CITY OF TAYLOR, TEXAS PLANNING AND ZONING COMMISSION MEETING

**City of Taylor
Castlewood Subdivision
Phases 2 & 3 Final Plat
PZ-2021-1352
Staff Report**

Will Buzzelli
Kimley-Horn
5301 Southwest Parkway, Building 3, Ste. 100
Austin TX 78735
william.buzzelli@kimley-horn.com

Permit Number PZ-2021-1352

20' WIDE PRIVATE ALLEY & UTILITY EASEMENT DETAIL "A"
SCALE 1:100

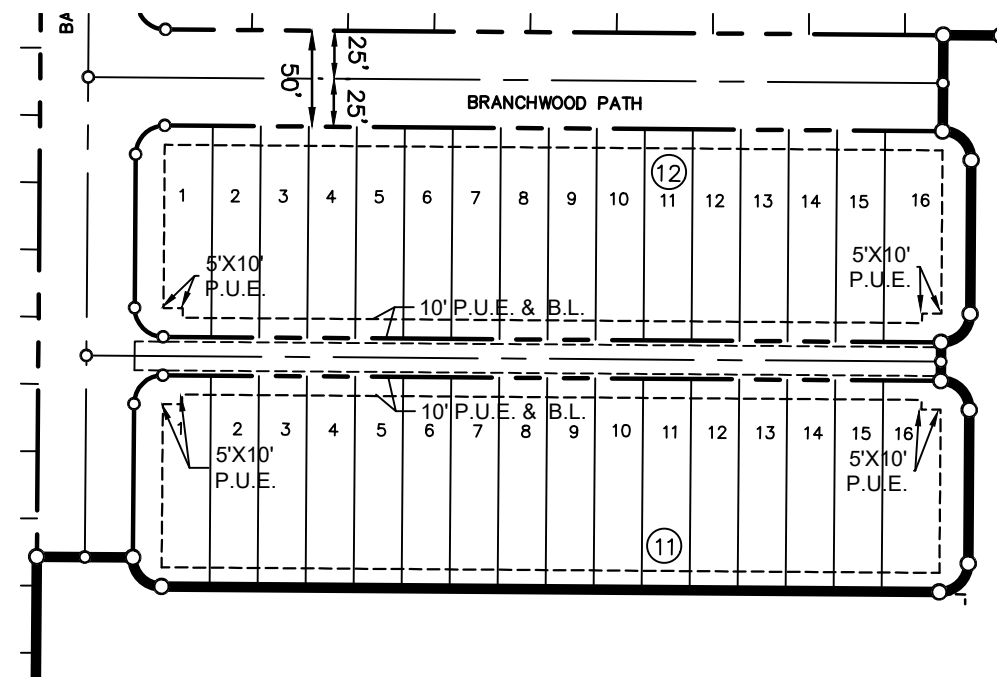
- For the Alley detail shown, update the blocks noted (17,18) with blocks shown on the plat.
- For the 20-ft wide private alley detail, dimension the 20-ft alley on the detail.

SINGLE-FAMILY LOT BUILDING
SETBACKS (B.L.) & PUBLIC UTILITY
EASEMENTS (P.U.E.)

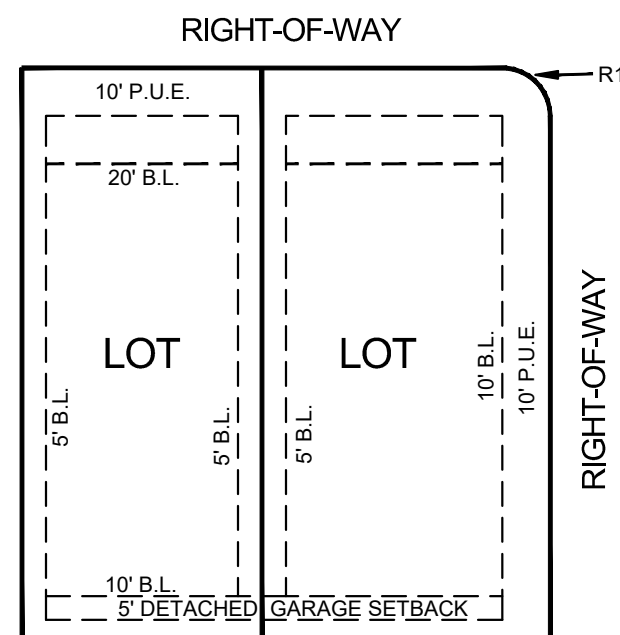
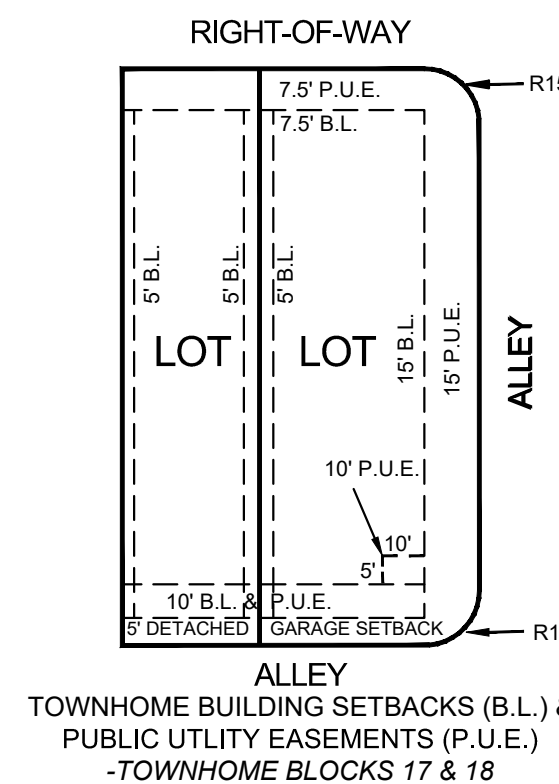
Make corrections to the rear easement and setback on the rear of each of the corner lots. It must look like the detail. Label the Details "A", "B", etc. so it's possible to discern one from the other. The easement and property line on the Final of Phase 1 are correct use it as a reference if you have trouble. The street side Building Line (at the end of each block of the townhomes) is 10-feet per the Planned Development Ordinance.

There is no detail for the twin-homes and/or duplex. The interior setback is 0 if the dwelling unit shares a wall. It is 5-feet if the dwelling unit does not share a wall.

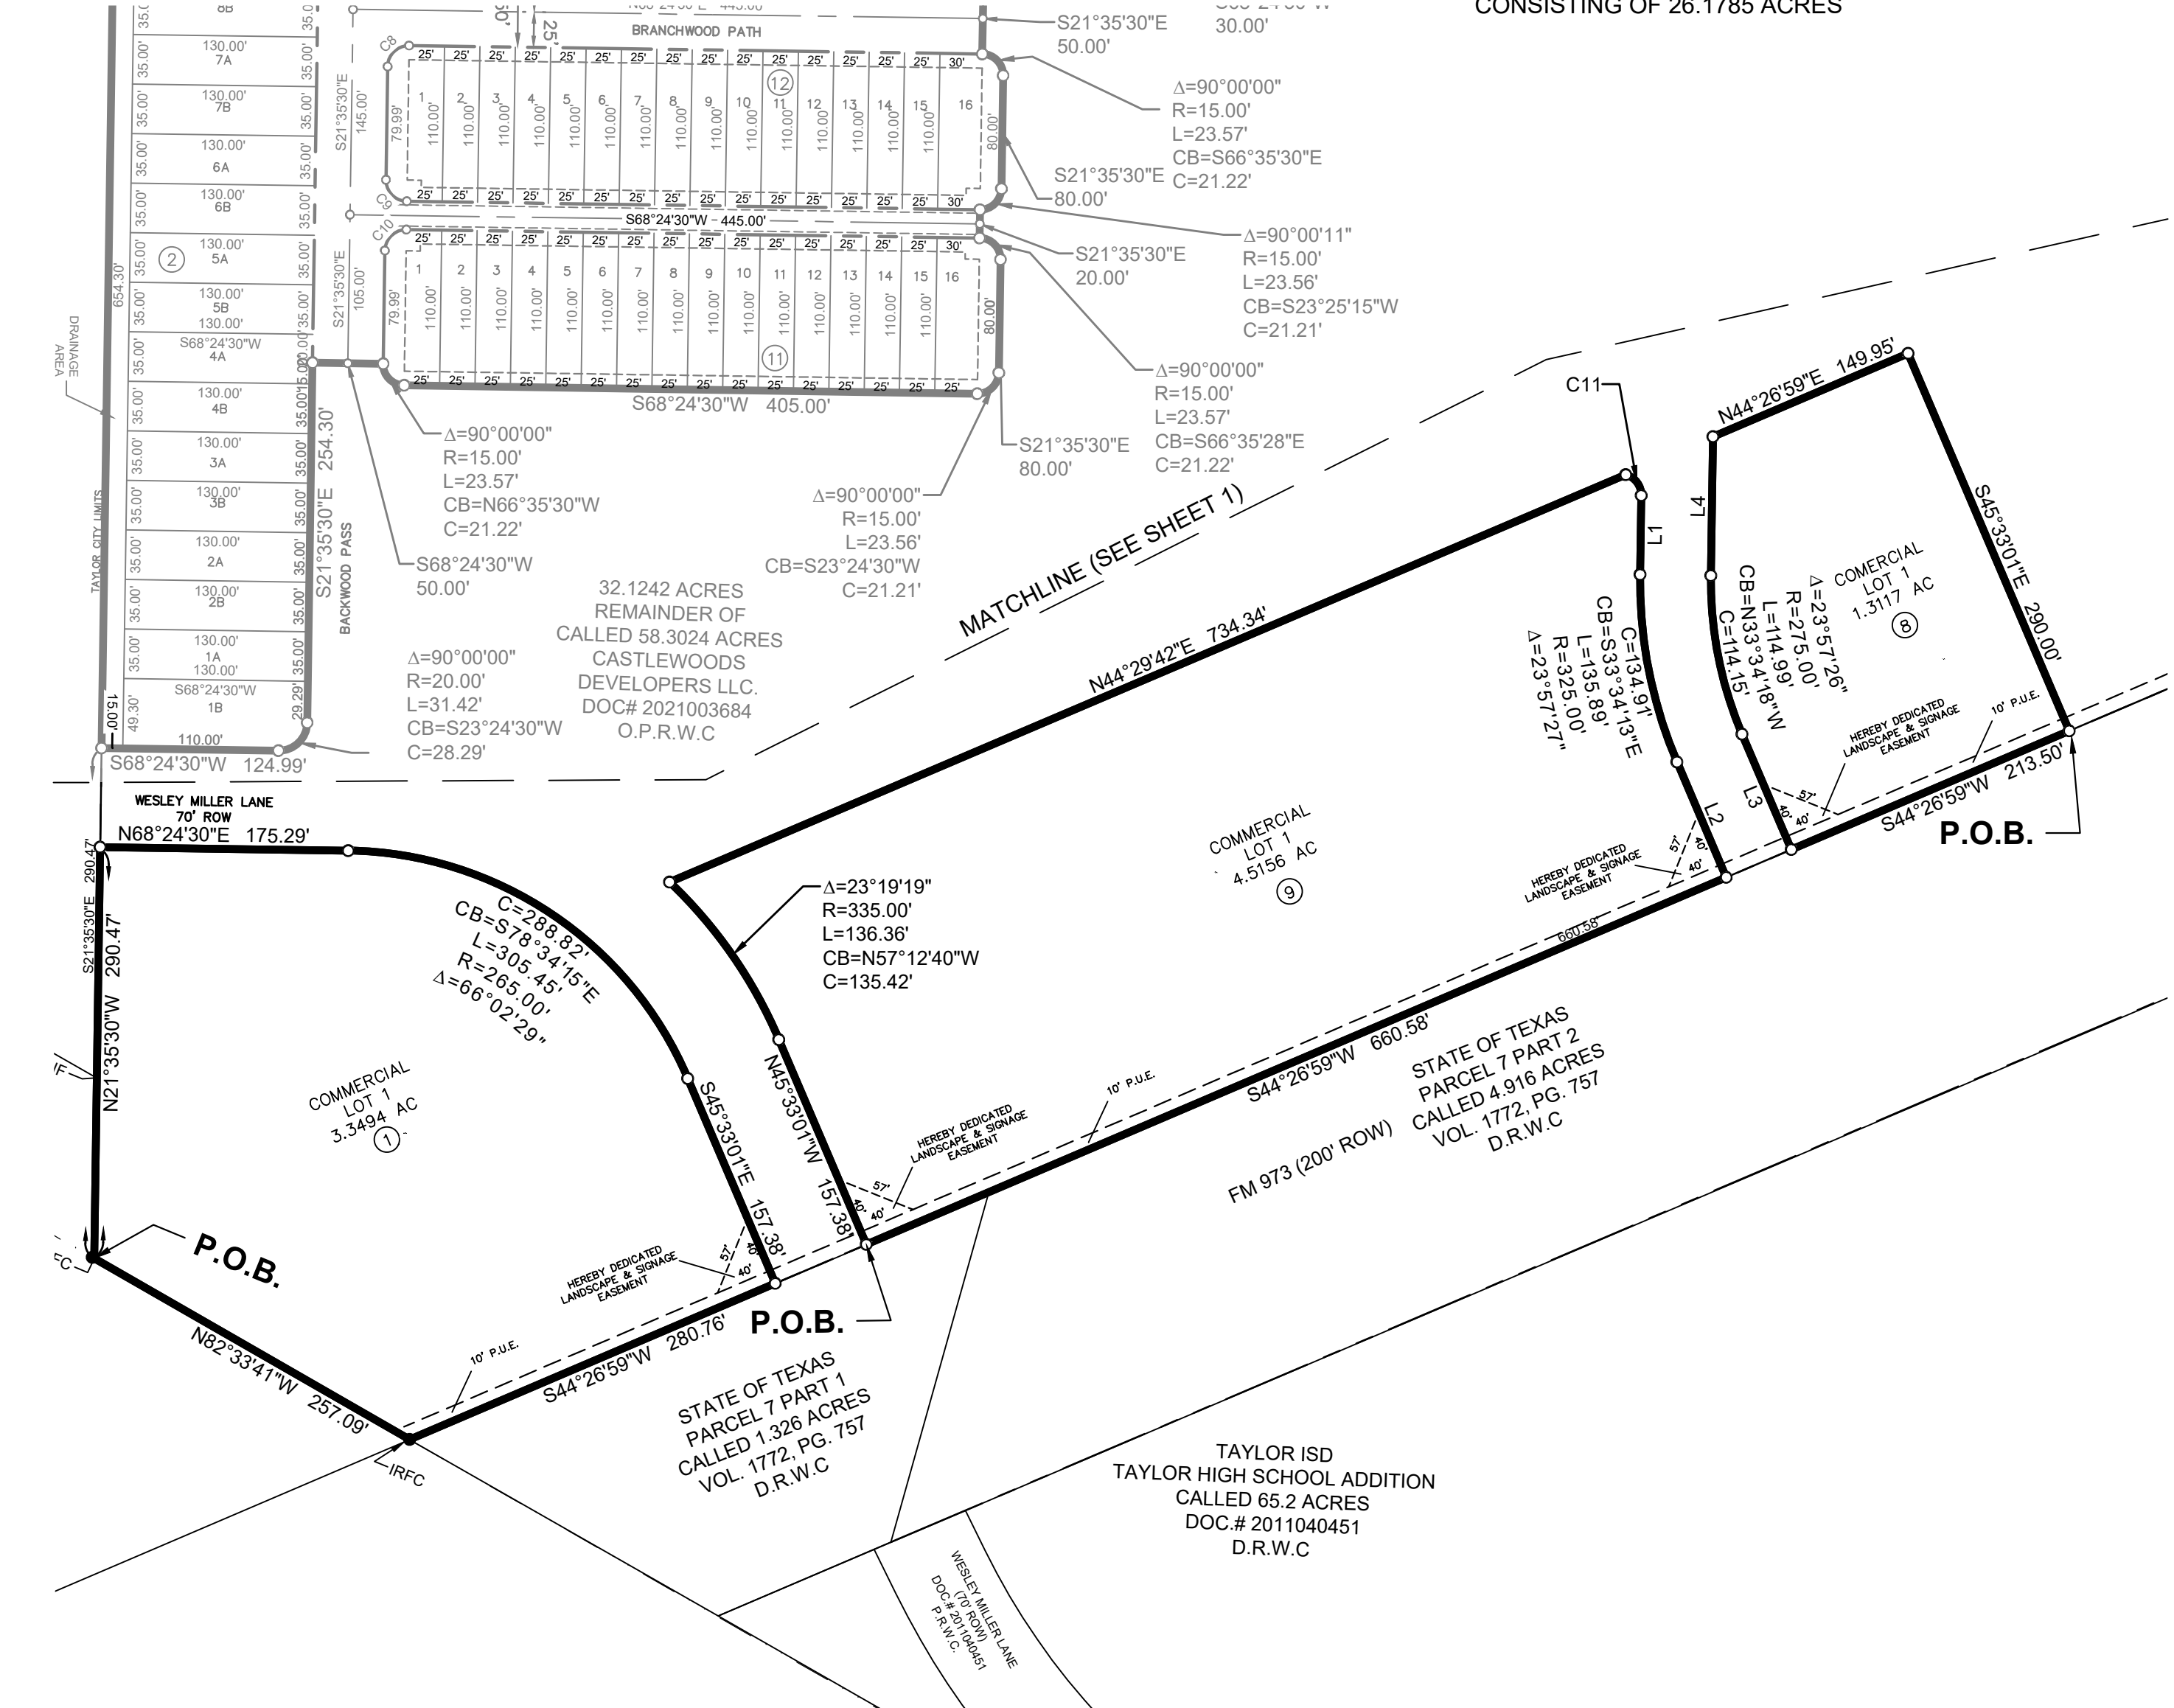
The plat description is incorrect as there are 114 lots, 9 blocks and one block is being finished. Make corrections to all sheets.

Insert the word "and" between "Lots 1-12" and "27-34". Remove the ";" after "27-34" just use a comma.

The plat is supposed to be 18" X 24". Make the correction under the scale on all sheets.

Add spaces between "2&3" so it should be "2 & 3" after the word Phase" which should be "Phases". Make the correction on each sheet.

- Format – Fix overlapping text where noted on the plat review drawing.
- Format – Show street name as part of the portion of Phase 1 area to be shown on the plat.

- Where noted on the plat review drawing (near Block 12,13), the central angle shown for the curve does not match the metes and bounds description
- Where noted on the plat review drawing (near Block 12), the chord bearing shown for the curve does not match the metes and bounds description

- Dimension and show ROW information for Blazed Trail street.
- For the drainage areas shown on the plat drawing, these areas are to be shown as a drainage reserve and verify they are shown respectively in the reserve table on Sheet 4

- Verify the bearing and distance shown near Lot 9A, Block 2. This does not appear to match the other location provided on this block.
- For the townhome blocks, (11,12) provide bearing and distance for lots as shown for other blocks.
